Agenda
Village of Glen Ellyn
Plan Commission Meeting
Thursday, May 4, 2023
7:00 PM
Glen Ellyn Civic Center, Galligan Board Room

STAFF REPORT

SUBJECT: 490 Kenilworth Avenue - Frank Johnson Center; Glen Ellyn Park District-Special Use Permit and Zoning Variation

REQUEST: Approval of a Special Use Permit associated with construction of a new maintenance facility, associated outdoor storage, and site development. In order to accommodate the project, the petitioner is specifically requesting approval of the following:

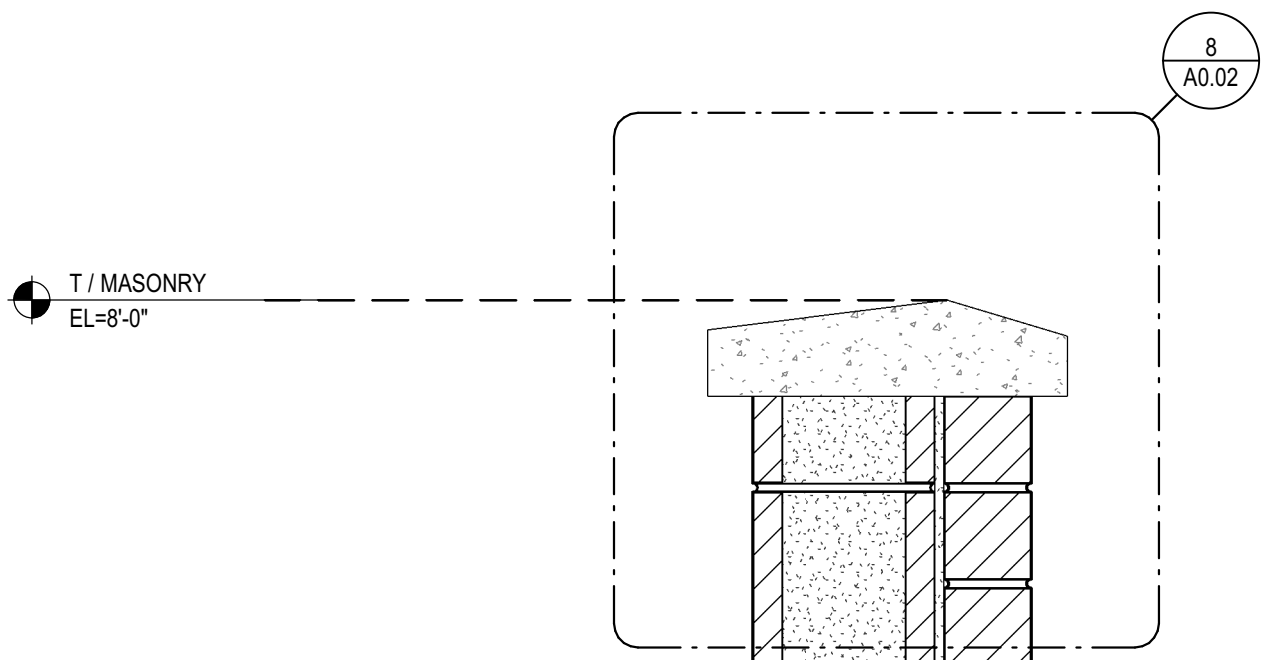
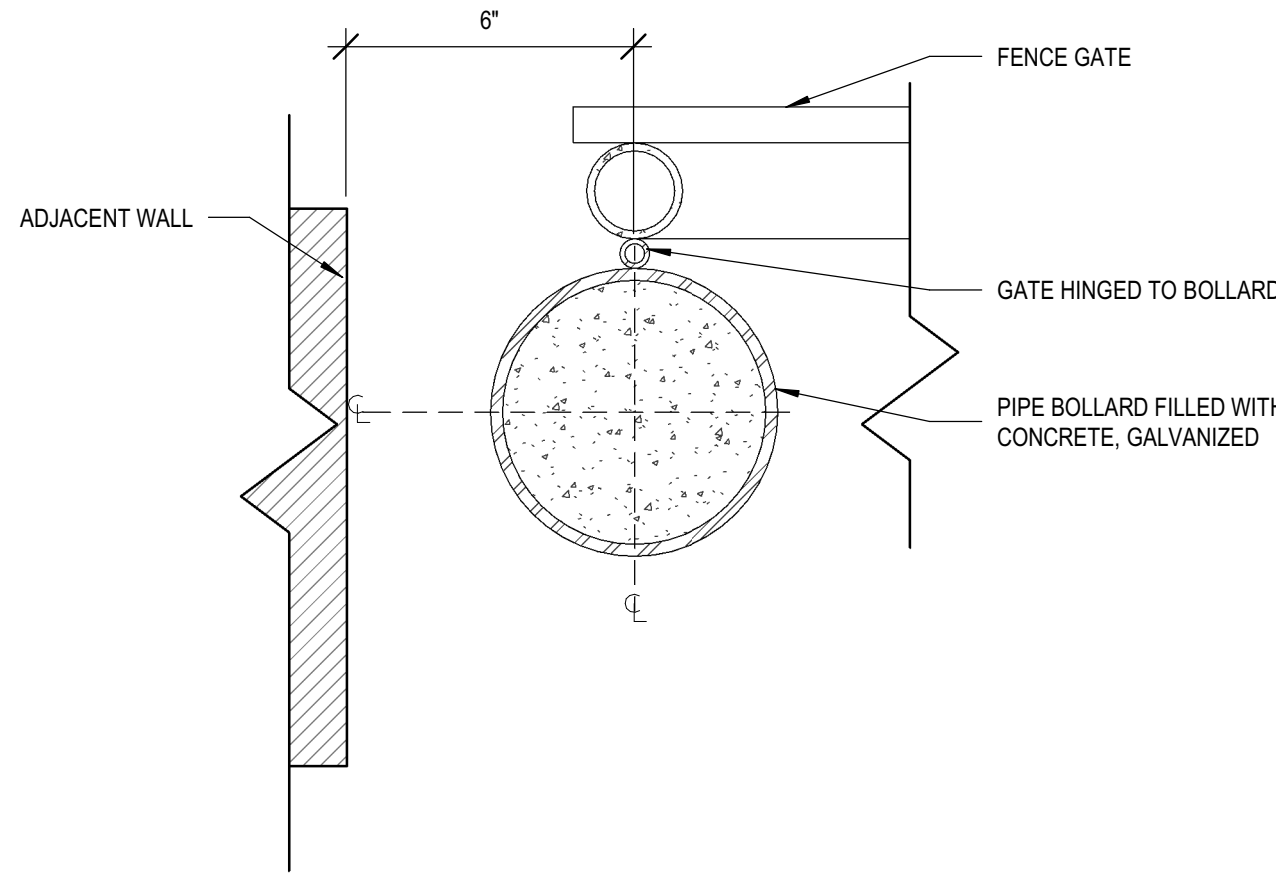
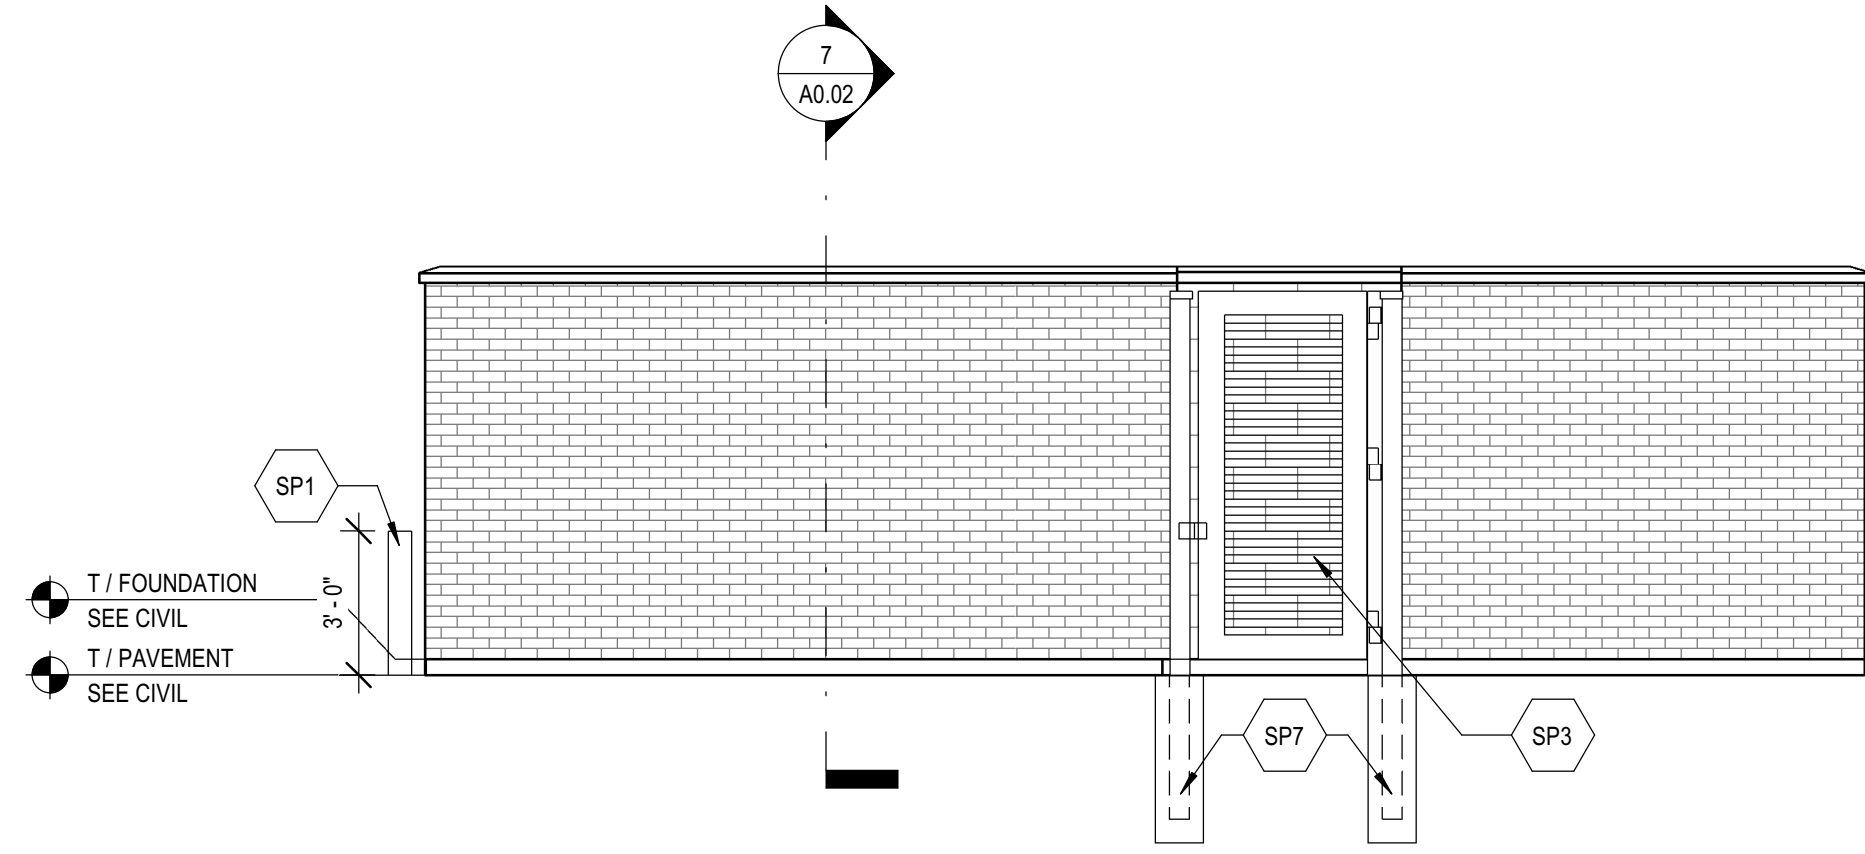
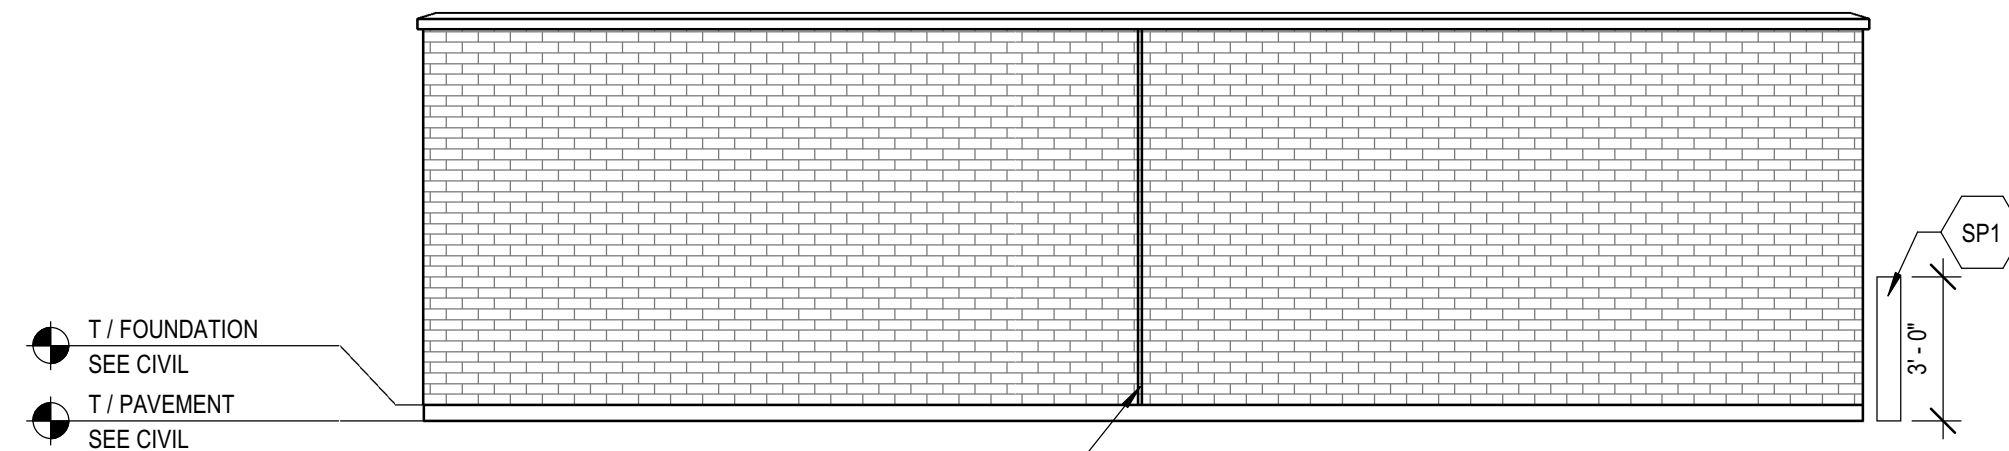
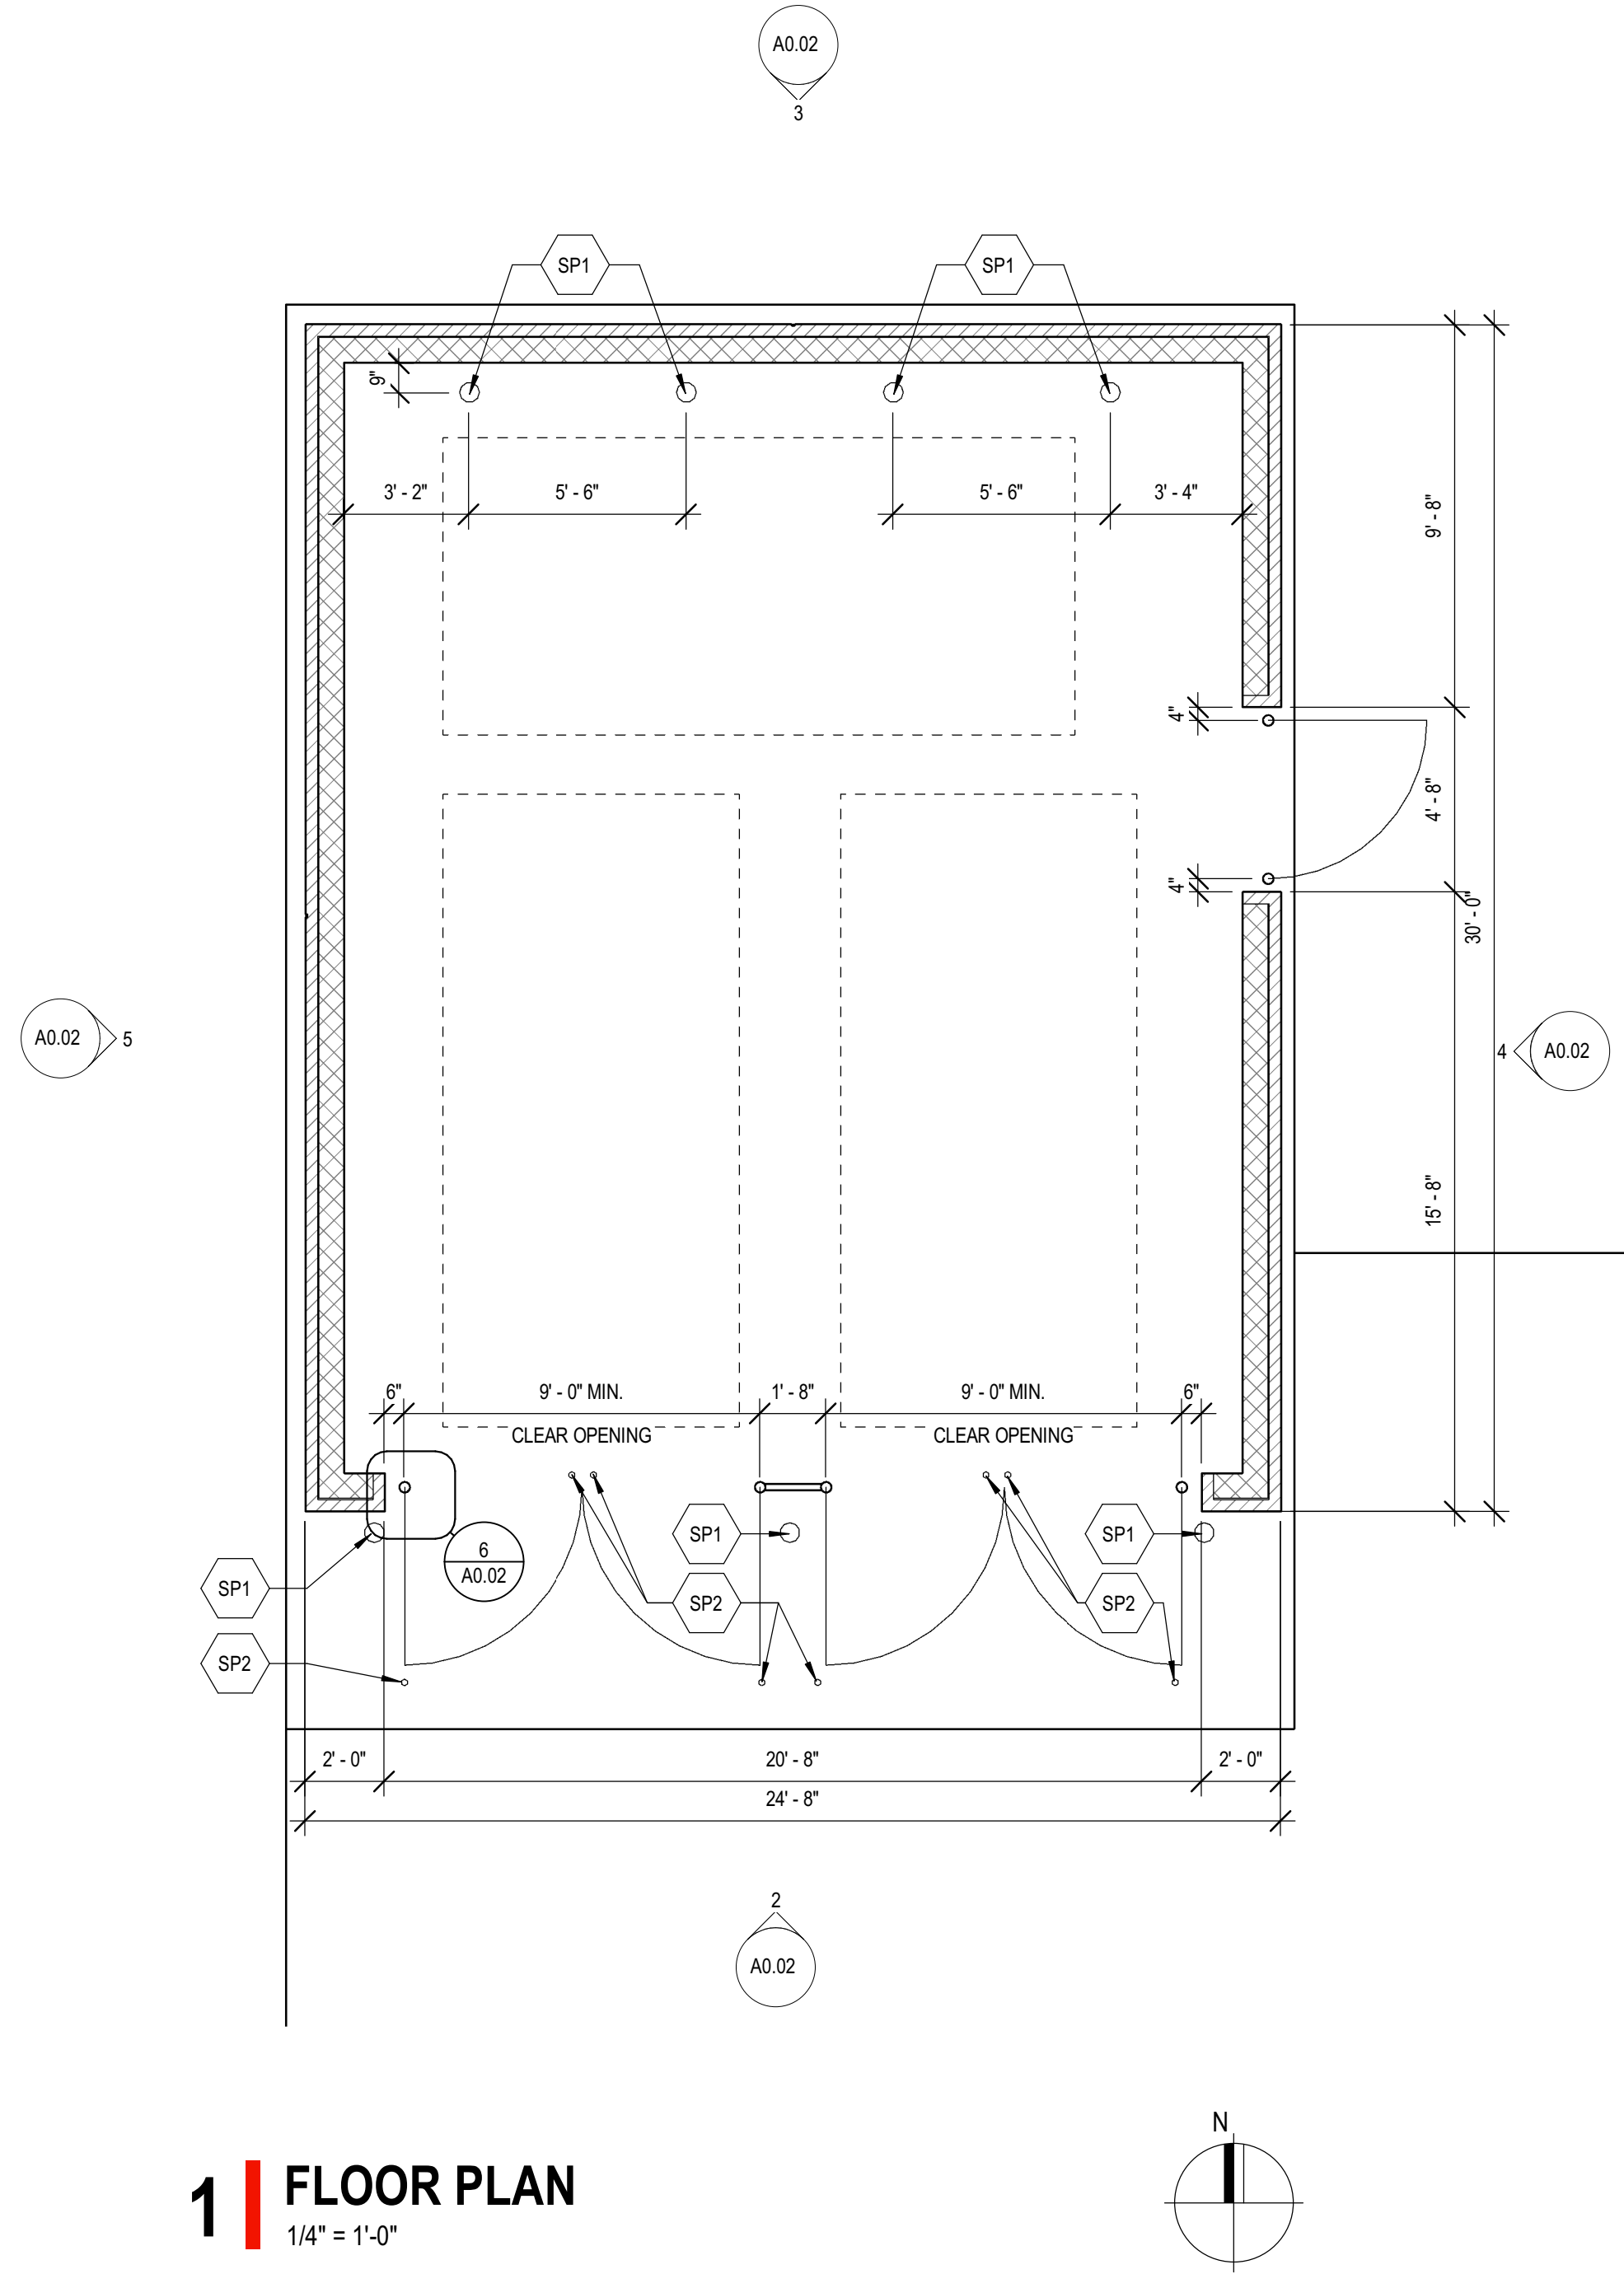
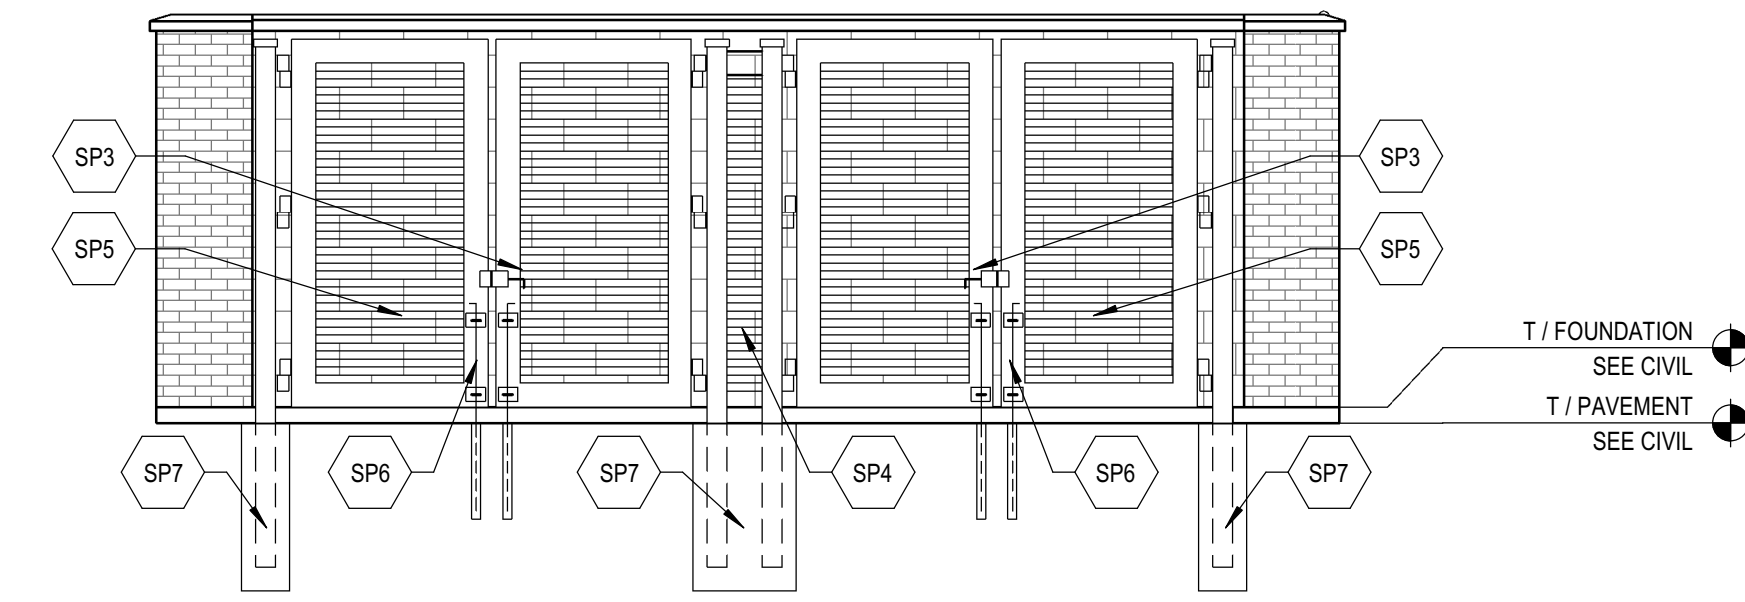
4. Trash Enclosure. A masonry trash enclosure is provided. The enclosure meets the Municipal Code for height as it is 8' with two metal gates and is open on the top.
